Access Compliance Report

Public Rights-of-Way

Intersection ID: 17926	Main Street: N_SHARON_AMITY_RD	Cross Street: RANDOLPH_RD	Location: SW
ADA ID: C13BF2FCC814	Ramp Type: PerpDiag	Initial Pass/Fail: Fail	Overall Compliance: No
Codes/Mitigation Info/Possible Solution		Field Measurements/Component Compliance	
Severity Score: 13.75

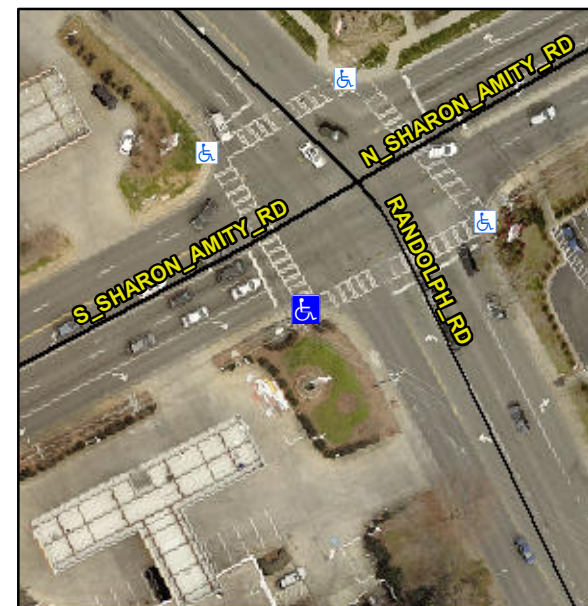
Compliance	Description	Data	Compliance	Description	Data
N/A	Ramp Length (in)	59.0	No	Ramp Slope (%)	11.8
Yes	Ramp Width (in)	48.0	No	Ramp XSlope (%)	3.8
N/A	Flare Type LT	N/A	N/A	Flare Type RT	N/A
N/A	Flare Slope LT (%)	N/A	N/A	Flare Slope RT (%)	N/A
N/A	Flare Traversable LT?	N/A	N/A	Flare Traversable RT?	N/A
N/A	Landing Length (in)	N/A	N/A	DWS Provided?	N/A
N/A	Landing Width (in)	N/A	N/A	DWS Contrast?	N/A
N/A	Landing Slope (%)	N/A	N/A	DWS Length (in)	N/A
N/A	Landing X Slope (%)	N/A	N/A	DWS Full Width?	N/A
N/A	Landing Curb? (Y/N)	N/A	N/A	DWS Offset (in)	N/A
N/A	Shared Landing?	N/A			
N/A	Gutter Ponding?	N/A	N/A	Gutter Slope (%)	N/A
N/A	Gutter Lip Ht (in)	N/A	N/A	Gutter X Slope (%)	N/A
N/A	Painted X Walk1?	Yes	N/A	Painted X Walk2?	Yes
	X Walk 1 Direction	To E		X Walk 2 Direction	To N
N/A	X Walk 1 Width (in)	112.0	N/A	X Walk 2 Width (in)	107.0
	X Walk 1 Slope (%)	7.8		X Walk 2 Slope (%)	3.6
	X Walk 1 X Slope (%)	3.8		X Walk 2 X Slope (%)	4.0

N/A	Ramp inside XWalk1?	Yes	N/A	Ramp inside XWalk2?	Yes
	Road Slope (%)	3.0	N/A	Clear Space?	N/A
	Road X Slope (%)	6.3	N/A	Clear Space to XWalk (in)	N/A
N/A	Any Obstructions?	N/A	N/A	Storm Grate/Utility Hazard?	N/A
	Obstruction Type			Storm Grate/Utility Type	
		N/A			N/A
		Yes		Surface Condition? (G/P)	Good

Remove & Replace Curb Ramp With Two New Directional Ramps or Equivalent.
